## Review of the Palisades Pressure Vessel Accumulated Fluence Estimate and of the Least Squares Methodology Employed

Patrick J. Griffin

This report provides a review of the Palisades submittal to the Nuclear Regulatory Commission requesting endorsement of their accumulated neutron fluence estimates based on a least squares adjustment methodology. This review highlights some minor issues in the applied methodology and provides some recommendations for future work. The overall conclusion is that the Palisades fluence estimation methodology provides a reasonable approach to a "best estimate" of the accumulated pressure vessel neutron fluence and is consistent with the state-of-the-art analysis as detailed in community consensus ASTM standards.

**Figure 5: Comparison of Palisades 47-Group Calculated Neutron Spectra with  $^{235}\text{U}$  Fission Spectrum**

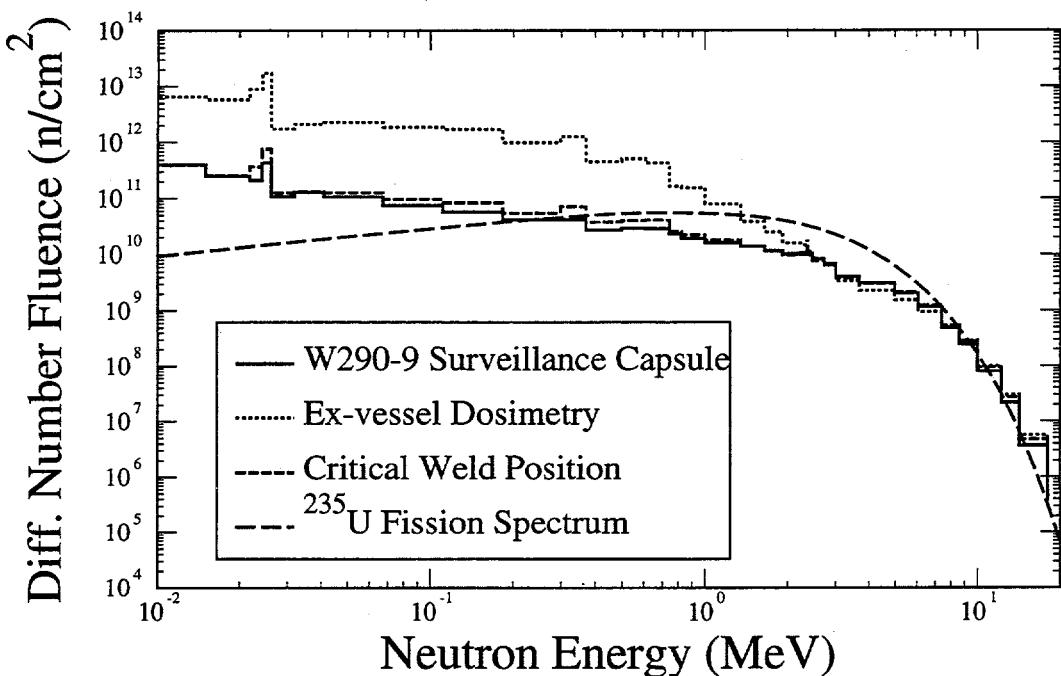
Figure 5 shows the Palisades calculated 47-group spectra for the W290-9 cycle 9 irradiation surveillance capsule position, the ex-vessel 16 degree cycle 9 irradiation dosimetry position, and the critical weld position (first octant equivalent 30 degree position at the reactor vessel clad/base metal interface) from the cycle 9 irradiation. Figure 5 also shows, for comparison purposes, a 640-group representation of the ENDF/B-VI  $^{235}\text{U}$  thermal fission neutron spectrum. All of the spectra in Figure 5 are renormalized so that the high energy part of the spectra are comparable. This figure shows that the cavity dosimetry neutron spectrum deviates from the pure fission spectra below about 6 MeV. The Palisades NRC submittal (page 24 of Attachment 1 of Enclosure 1, Consumers Energy Submittal Dated June 12, 1996) indicates that all fluence bins above 5.5 keV have a short range correlation with a range of  $\gamma=6$  groups and a fairly strong correlation strength of  $\Theta=0.9$ . I feel that this is too strong a correlation over the region where the pure fission part of the spectrum transitions to the  $1/E$  behavior.

One piece of data in the Palisades' submittal does raise some concern about this equivalence of spectra. The Tables 4.1-5 thru 4.1-15 on page 4-11 thru 4-21 compare the azimuthal variation in the neutron spectrum. These tables show a 13% variation in the  $\phi(E>0.1)/\phi(E>1.0)$  metric at 20 degrees - the location of the surveillance capsule. This possible variation between the spectra at the surveillance capsule and at the critical weld is a concern. A variation in the clad-base metal fluence ratios (greater than 0.1 MeV divided by greater than 1-MeV) at the azimuthal position of the surveillance capsule raises a question about the deviation of the neutron spectrum induced by the presence of the surveillance capsule. If the spectra are not very close in shape, then it is legitimate to request that a statistical correlation be established between the two calculated spectra with a sensitivity analysis. I am not sure how to reconcile this deviation in the azimuthal symmetry with the good agreement between the calculated spectra at the surveillance capsule and that at the critical weld, as depicted in Figure 5.

Figures 5 and 8 show plots in differential number and energy space of the in-vessel and ex-vessel calculated spectra as well as the calculated neutron spectrum at the critical weld location. These plots agree with the trend I have seen in other sources [He93]. Significant spectral shape differences are seen between the in-vessel and ex-vessel spectral shapes. One can argue that the calculated spectrum at the critical weld location is virtually identical to that for the surveillance capsule, and thus is strongly correlated. But this argument can not be extended to include the ex-vessel cavity dosimetry.

In the absence of this sensitivity analysis to correlate the two spectra (and hence the bias factors) I suggest that Palisades only use the bias factors from the surveillance capsule locations. The consistency of the bias factor at the surveillance capsule positions needs to be examined. An examination of the Palisades Table 7-1.1 on page 7-3 suggests that this approach might change the average “best estimate” bias factor from 0.831 +/- 0.067 to 0.8345 +/- 0.013. This is not a significant change to the Palisades request, but it avoids some difficult questions about the application of the cavity dosimetry data. The only drawback associated with this approach is that it reduces the dataset of bias factors to four values.

**Figure 8: Differential Energy Representation of the Neutron Environment at the Calculated Dosimetry Positions**

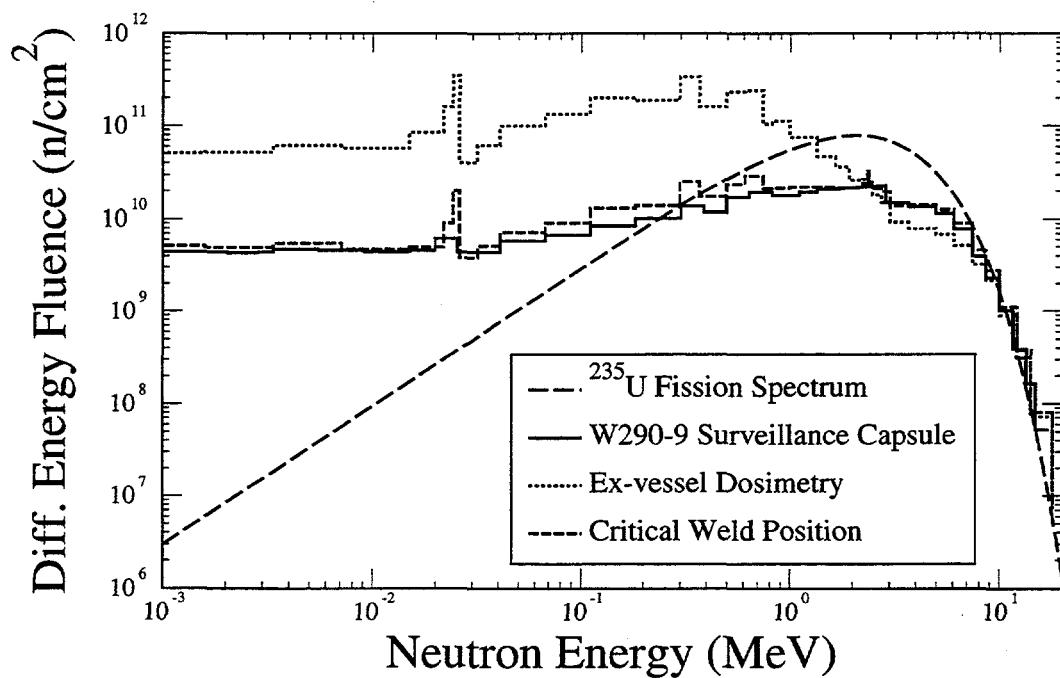
Figure 8 shows the differential energy representations of the same spectra. Note that the curves in this figure are arbitrarily normalized so that the high energy parts of the spectra overlap. There are no obvious artifacts in the spectral representations that would indicate a problem with the calculated spectrum determination. The ex-vessel calculated neutron spectrum exhibits a change in behavior below about 3-MeV. The cause of this change in behavior is not clear to the author, but the calculated neutron spectra are smooth enough so as not to raise any overriding concern about the fidelity of the calculation. The differential energy representation shows that the surveillance capsule calculated neutron spectrum is nearly identical to the calculated spectrum at the critical weld position. However, one can see very significant shape changes between the spectral shape at the ex-vessel dosimetry location and that at the critical weld. This is a matter of concern that will be addressed in Section 14.

**Figure 9: Logarithmic Differential Energy Representation of FERRET-Adjusted Neutron Environment at the Surveillance Capsule Location**

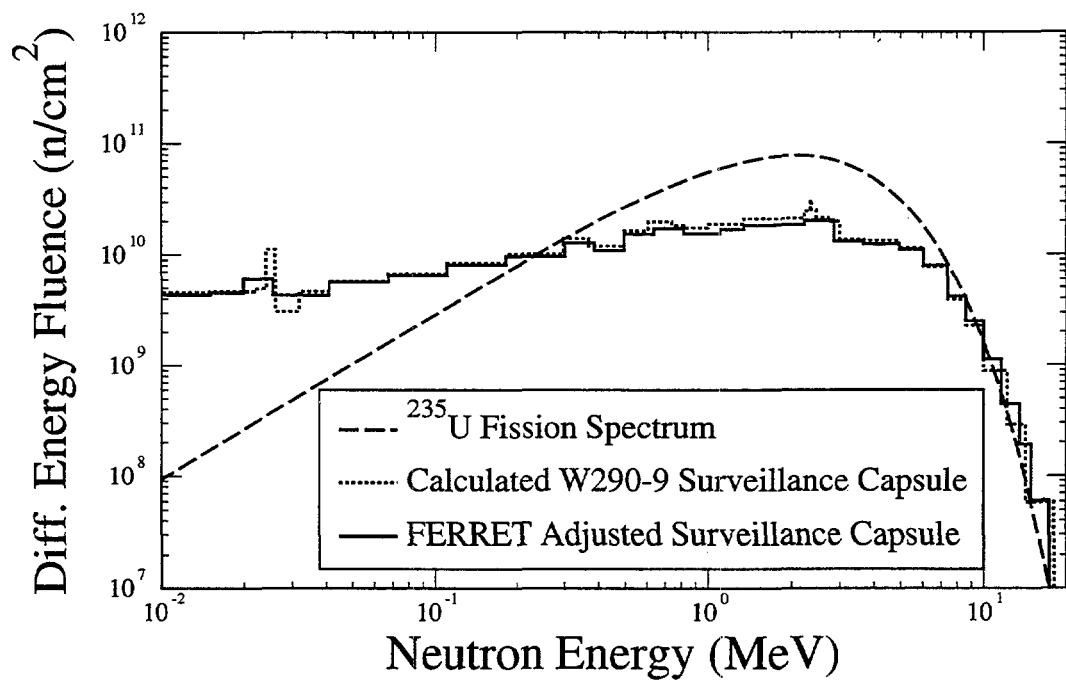
To be consistent with this analysis, the FERRET adjusted spectrum should be subjected to the same inspection. Figure 9 shows the differential energy representation of the W290-9 53-group FERRET adjusted spectrum in logarithmic energy space. Again no unusual artifacts are seen. The FERRET adjusted spectrum is practically indistinguishable from the calculated spectrum when viewed in logarithmic energy space. Some difference is seen near the 25-keV transmission window in iron. The BUGLE calculated spectrum has a more well defined transmission peak, partly due to the fact that the BUGLE energy structure was designed to address this transmission window. A transmission window near 2.5-MeV is also seen in the calculated spectrum. This window is not seen in the adjusted spectrum, but this could, again, be attributed to the energy bin structure. The exact cause of this 2.5-MeV window is not known to the author, but the transmission corresponds to a very small energy bin in the BUGLE cross sections that was presumably placed in the energy bin structure to accommodate some feature of the reactor pressure vessel cross sections.

**Figure 10: Linear Differential Energy Representation of FERRET-Adjusted Neutron Environment at the Surveillance Capsule Location**

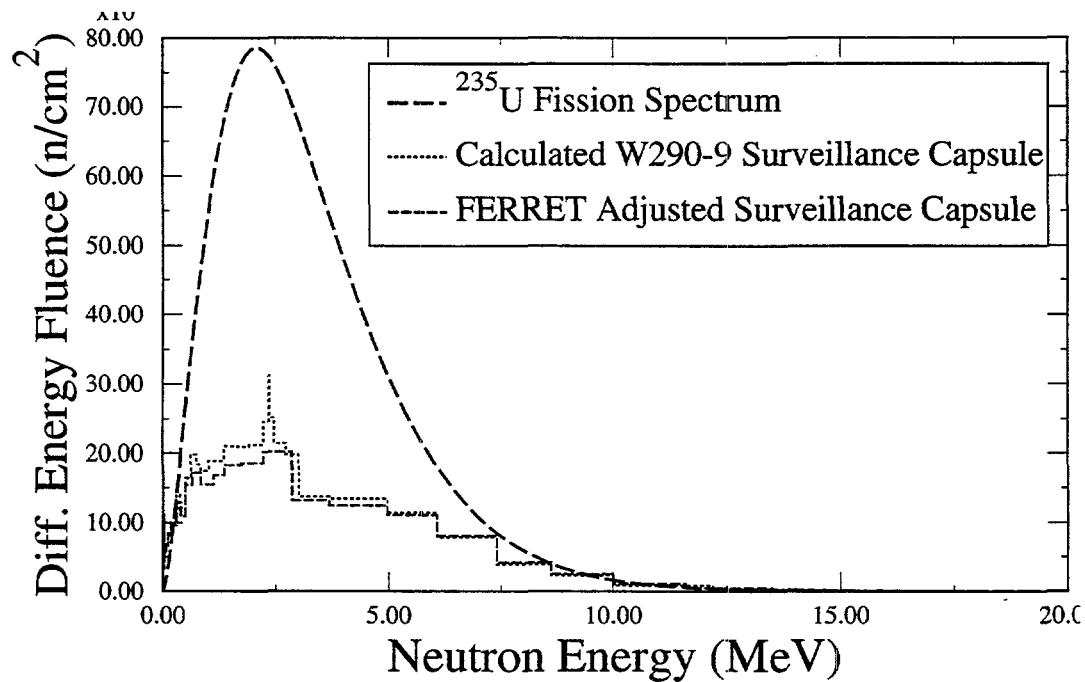
Figure 10 shows the same neutron spectra in linear energy space. The difference between the calculated and FERRET-adjusted spectrum is still small in this figure. The difference is seen between about 3-MeV and 1-MeV. This adjustment behavior is consistent with the least squares methodology. The *a priori* neutron spectrum can only be adjusted in regions where there are reaction rate data to force an adjustment. To resolve the discrepancy between the  $^{64}\text{Cu}(\text{n},\alpha)$  and  $^{58}\text{Ni}(\text{n},\text{p})$  &  $^{54}\text{Fe}(\text{n},\text{p})$  reactions, the spectrum adjustment is made below the  $^{64}\text{Cu}(\text{n},\alpha)$  threshold and only extends through the  $^{58}\text{Ni}(\text{n},\text{p})$  &  $^{54}\text{Fe}(\text{n},\text{p})$  thresholds in so far as is demanded by the stiffness of the spectrum correlation function. One can also see from the figure that the difference between the transport spectrum and the least squares adjusted spectrum is small relative to the radiation transport modification on the  $^{235}\text{U}$  source fission neutron spectrum.
